# Findings of Fact and Conclusion

## *TH 169/101<sup>st</sup> Avenue Interchange Project*

*S.P. 2750-92*

**RGU: Minnesota Department of Transportation**

Figure 3

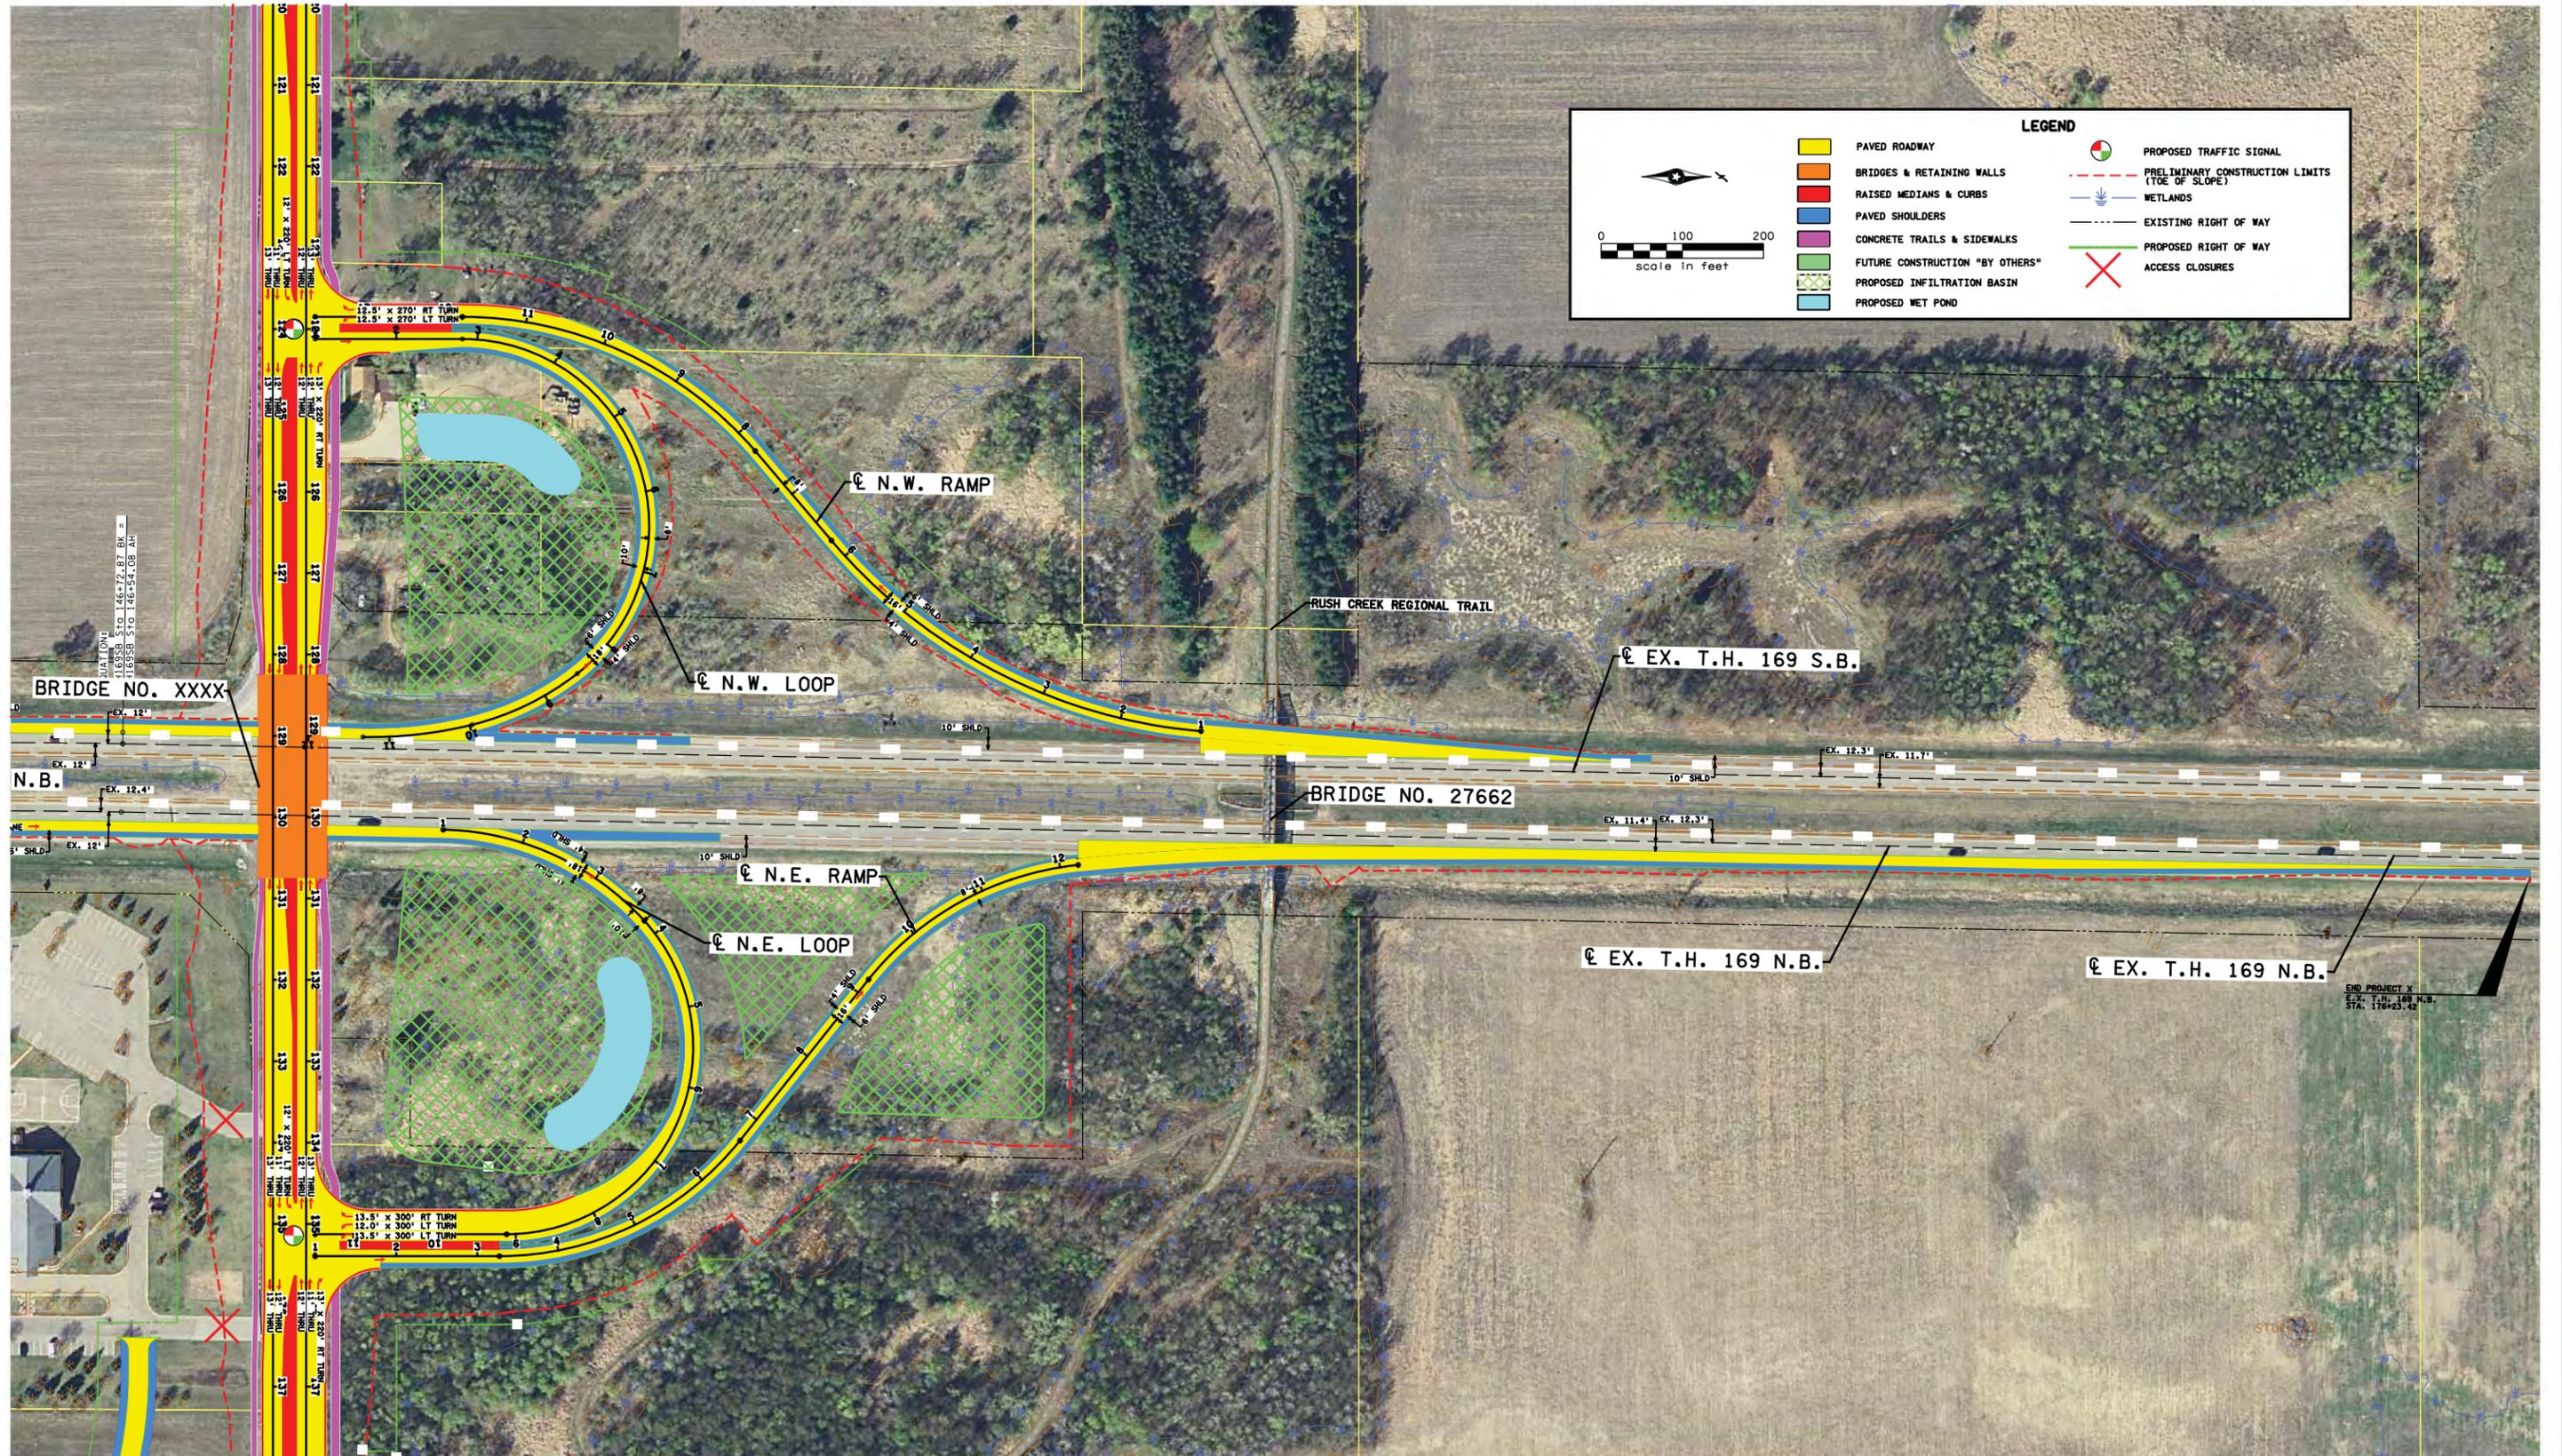
Note that the proposed stormwater pond located in the southeast corner of the 101<sup>st</sup> Avenue/Jefferson Highway intersection has been sized to accommodate the additional impervious surface and footprint associated with a roundabout design (see Figure 3, Appendix A).
